ADDENDUM TO
SPECIFICATIONS ENTITLED
"SPECIFICATIONS FOR
HFR BUILDING
65 WEST UNIVERSITY WAY
CULLOWHEE, NORTH CAROLINA 28723
ROOF REPLACEMENT PROJECT
SCO ID NO. 22-24898-01A"

ADDENDUM NO. 2

JUNE 16, 2023

Figure 1: Existing Framing Plan

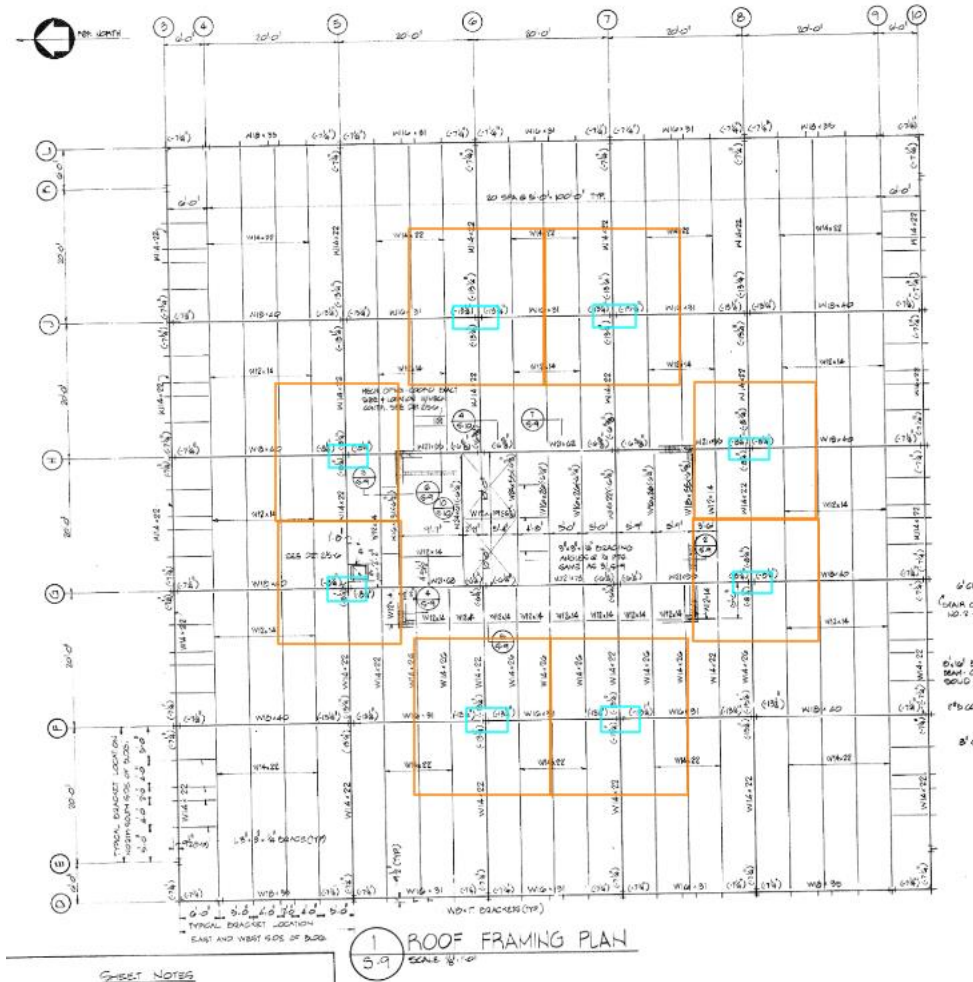
1. Can we use a roof top hoist to move material from the lower roof to the main roof. The lower roof being the one that is adjacent to the temp road .
 - a. *No roof top hoists can be used. However, a hoist/elevator system could be considered with the scaffolding erector and their engineers.*
2. How much material can we store on the upper roof spread out
 - a. *Contractor may load roof as follows. See Figure 1: Existing Framing Plan for reference:*
 - i. *Materials with a bearing pressure less than 12 lbs/sf may be placed anywhere.*
 - ii. *Materials exceeding a bearing pressure of 12 lbs/sf shall be placed over the existing columns (identified in light blue). Load directly over columns shall be limited to 4000 lbs with a maximum bearing area of 32sf. No additional materials may be stored within the tributary area of the column (orange rectangle)*

Figure 2: Locations of Utilities

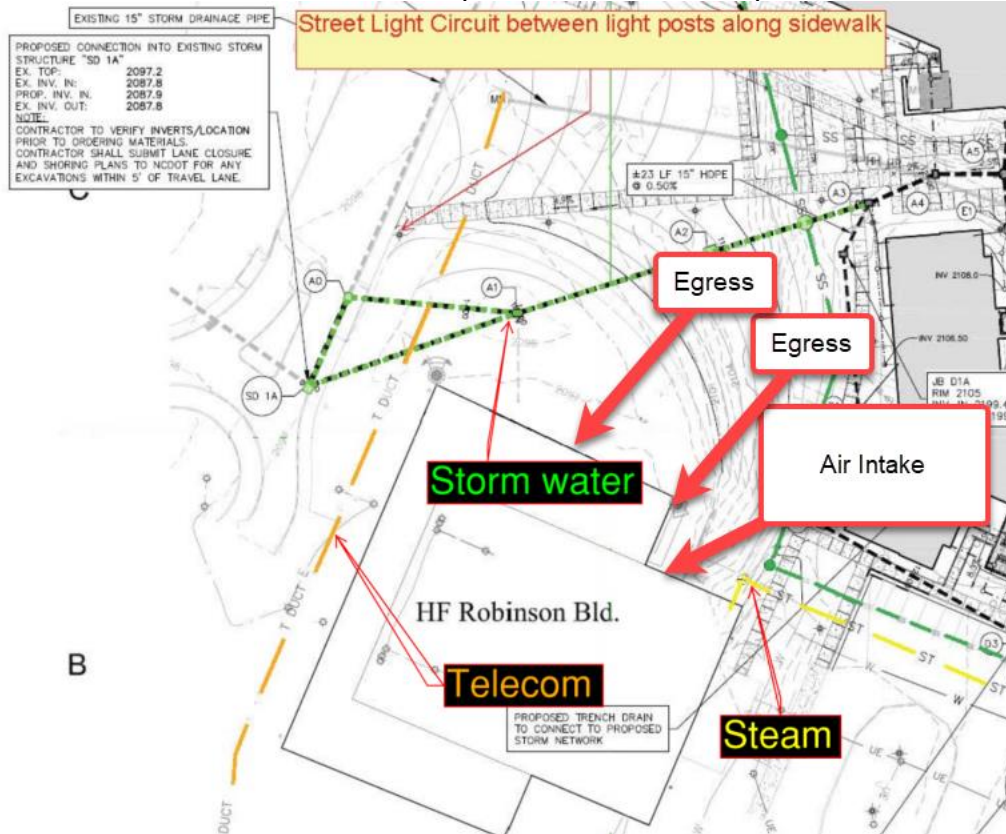
6. The temp road fenced in area , can we have full use of that area for small Lay-down and equipment storage, along with dumpster use there.
 - a. *Yes, so long as both egress doors and pathways remain accessible at all times, utilities/buildng are not damaged and the large tree nearest the cooling tower is protected (Figure 2: Locations of Utilities). Contractor is responsible restoring the*

grounds as required in the project documents. Stair tower within this area shall be wrapped in fabric to catch falling debris. The air intake below the location of the stair tower will need to be protected from debris, particulates, and odors.
